City of Lawrenceville Engineering Department

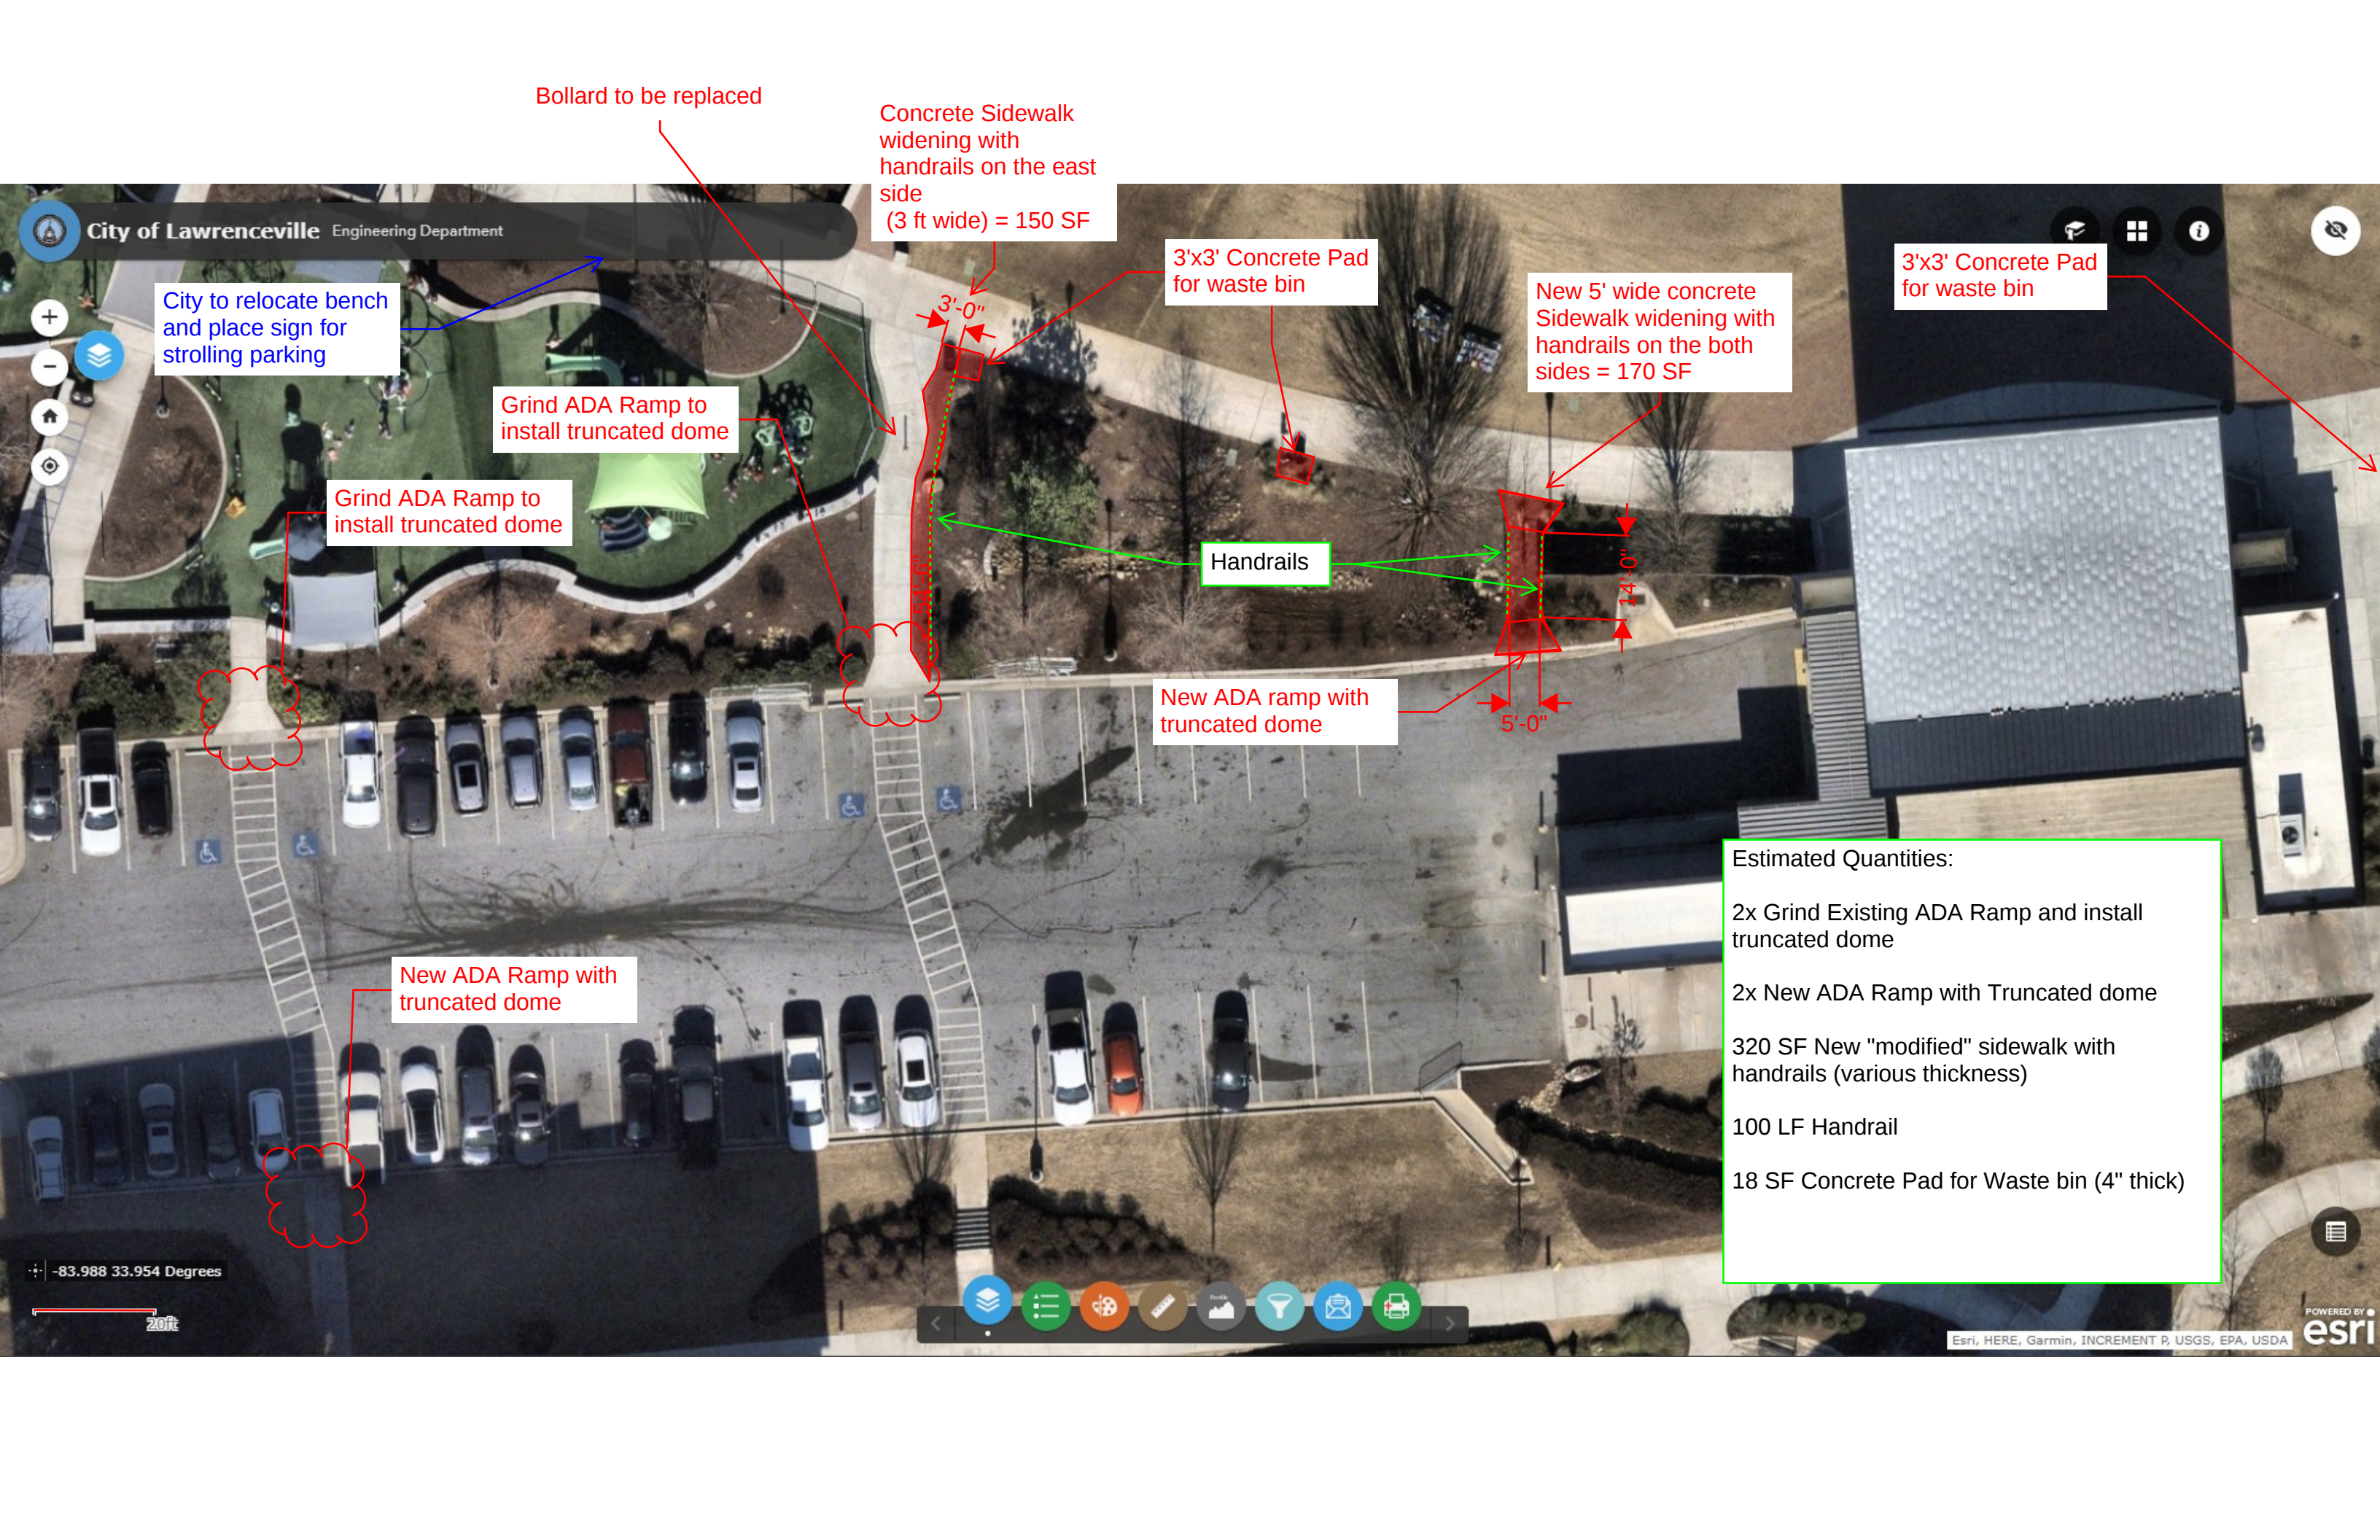
City to relocate bench and place sign for strolling parking

Grind ADA Ramp to install truncated dome

Grind ADA Ramp to install truncated dome

New ADA Ramp with truncated dome

Bollard to be replaced

Concrete Sidewalk widening with handrails on the east side (3 ft wide) = 150 SF

3'x3' Concrete Pad for waste bin

New 5' wide concrete Sidewalk widening with handrails on the both sides = 170 SF

3'x3' Concrete Pad for waste bin

Handrails

New ADA ramp with truncated dome

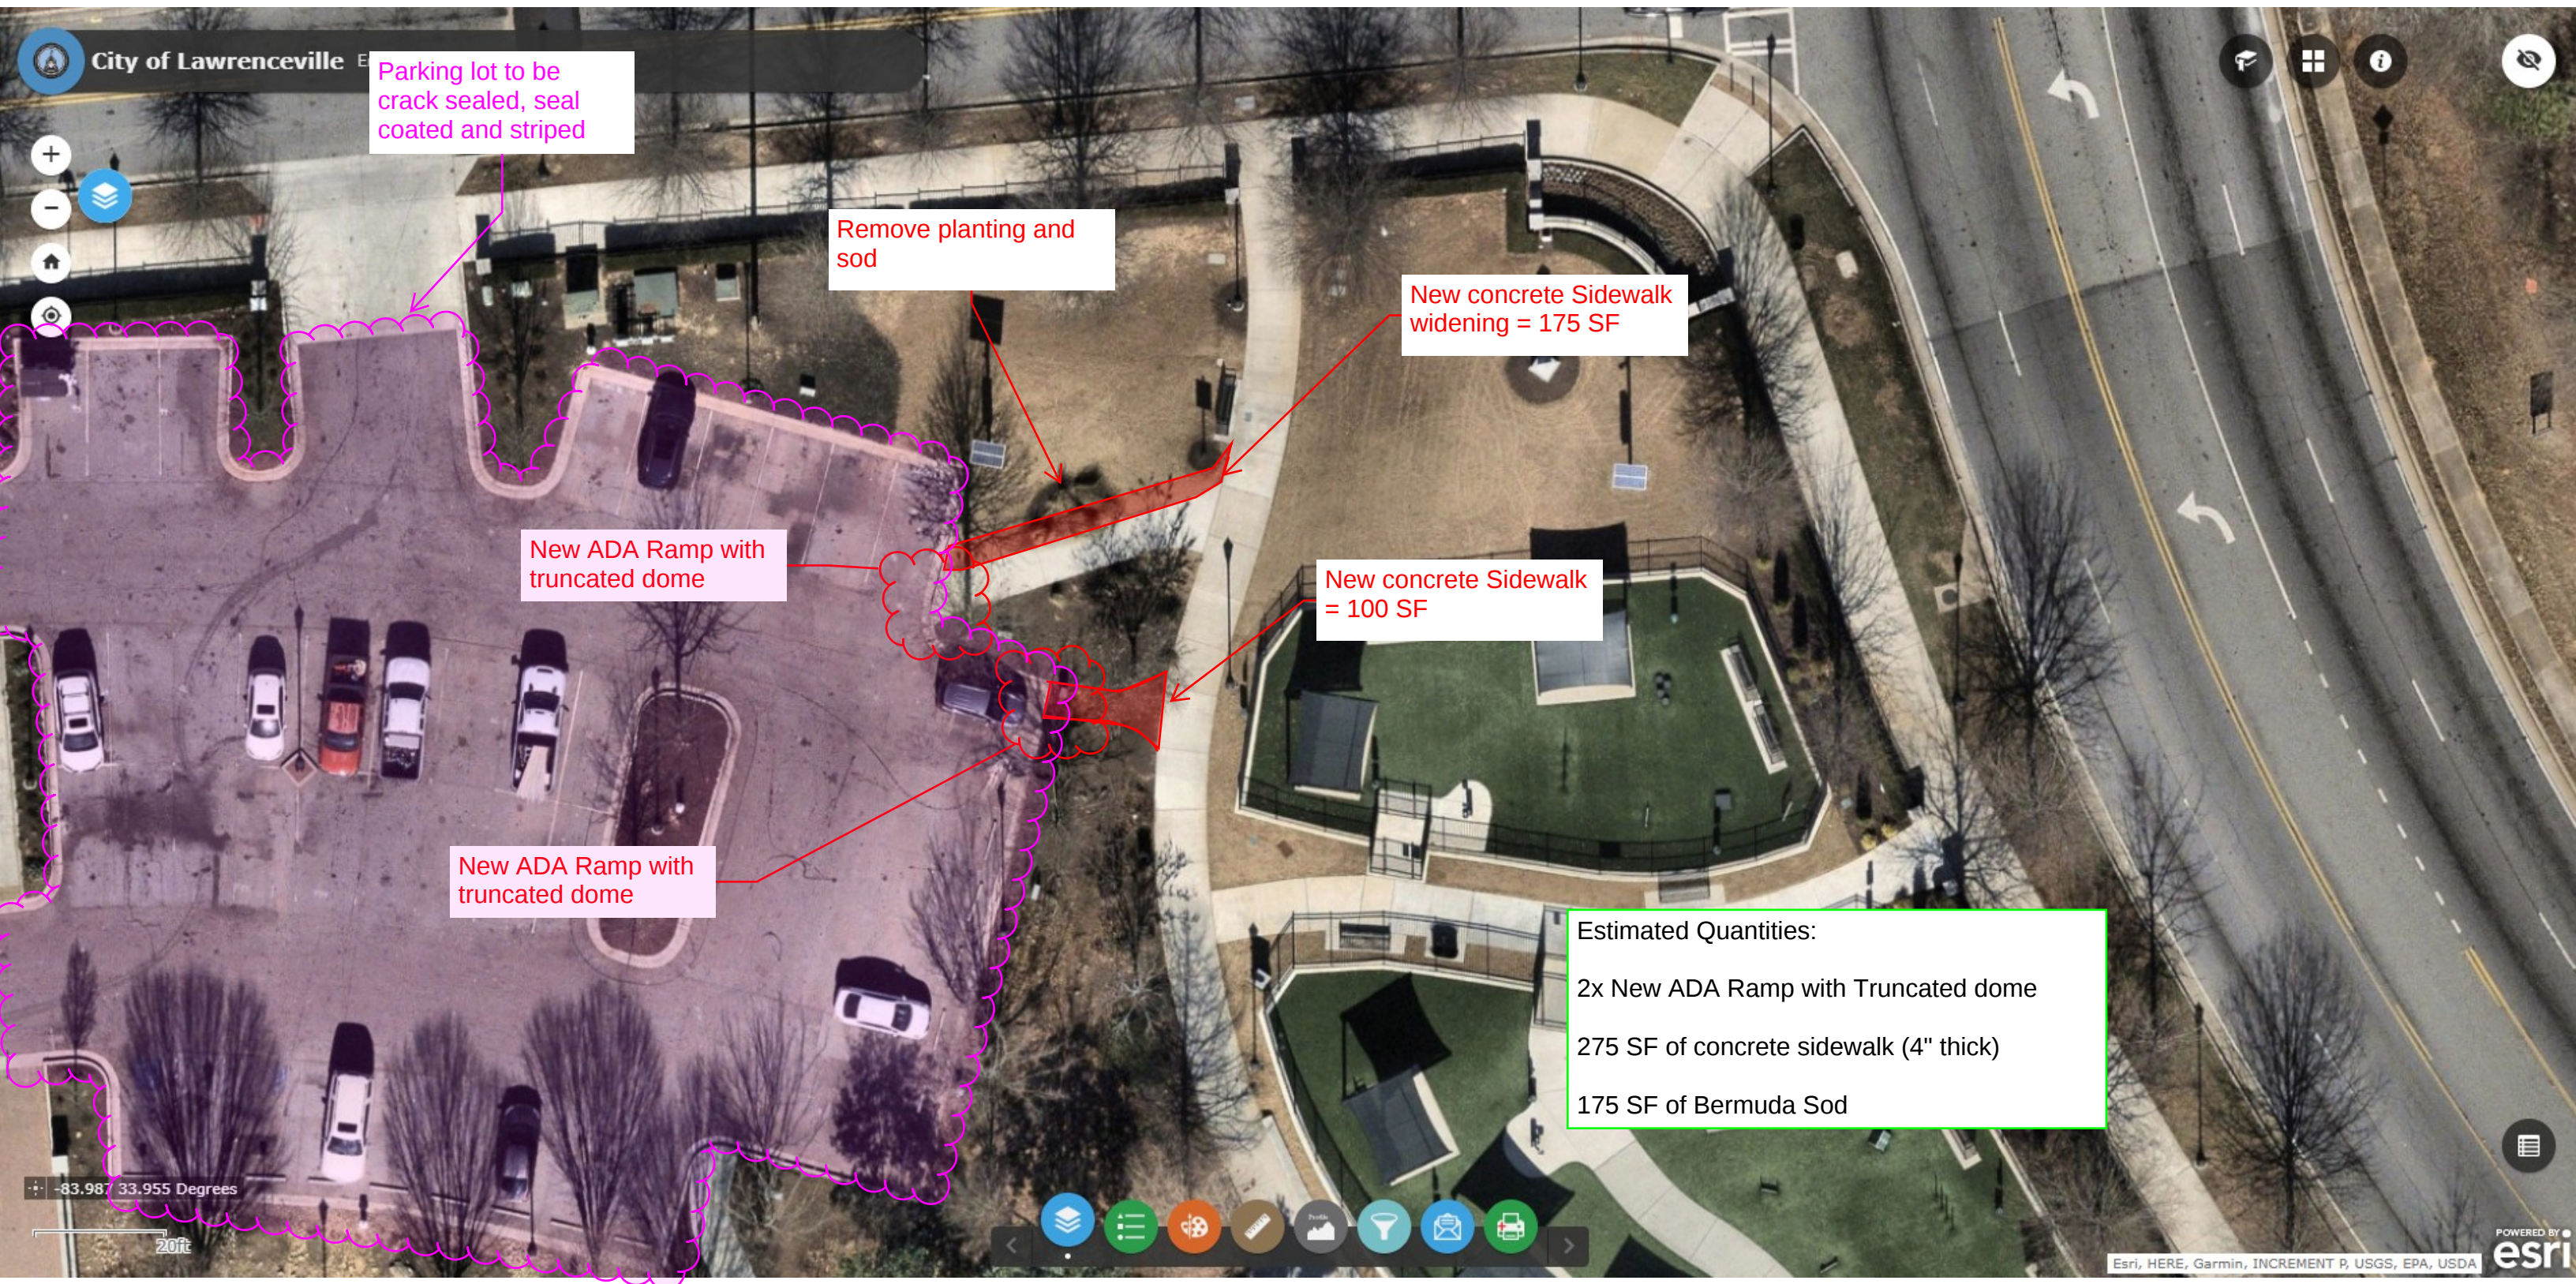
3 ft Concrete sidewalk
widening (4" thick)

Parking lot to be
crack sealed, seal
coated and striped

Remove planting and
sod

New concrete Sidewalk
widening = 175 SF

New ADA Ramp with
truncated dome

New concrete Sidewalk
= 100 SF

New ADA Ramp with
truncated dome

Concrete sidewalk plaza (4" thick)
= 1560 SF

Remove Bike Rack

3 ft Concrete sidewalk widening (4" thick)
= 425 SF

Parking lot to be crack sealed, seal coated and striped

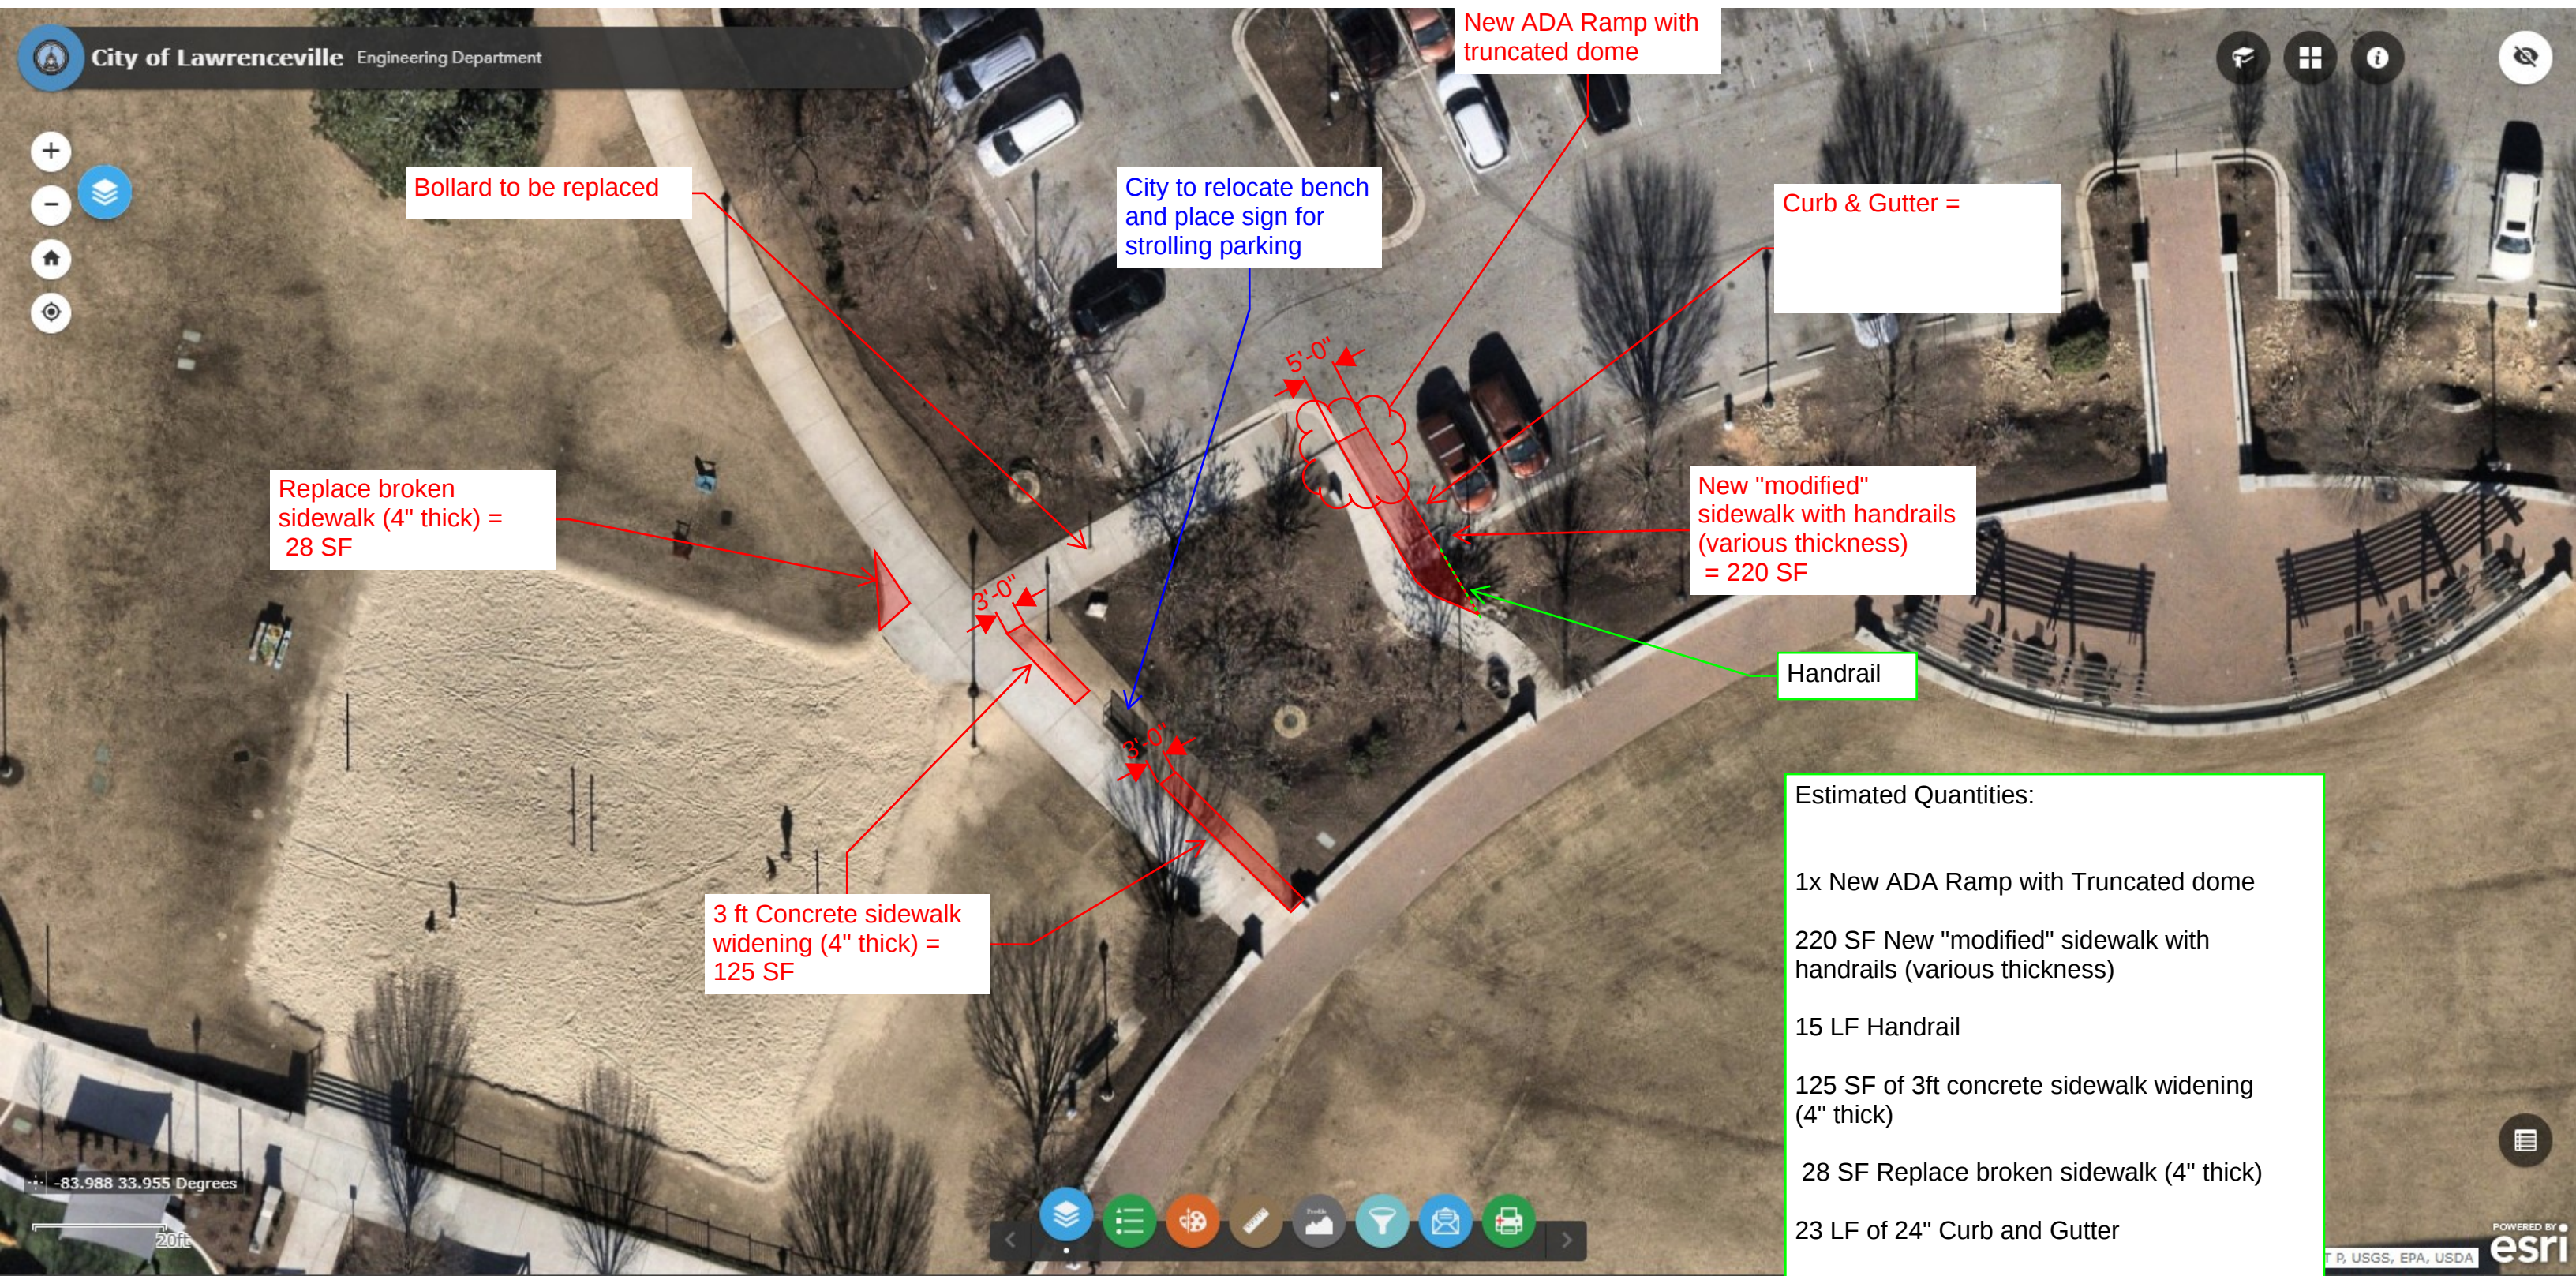
Bollard to be replaced

City to relocate bench and place sign for strolling parking

New ADA Ramp with truncated dome

New "modified" sidewalk with handrails (various thickness) = 220 SF

Handrail

Replace broken sidewalk (4" thick) = 28 SF

3 ft Concrete sidewalk widening (4" thick) = 125 SF
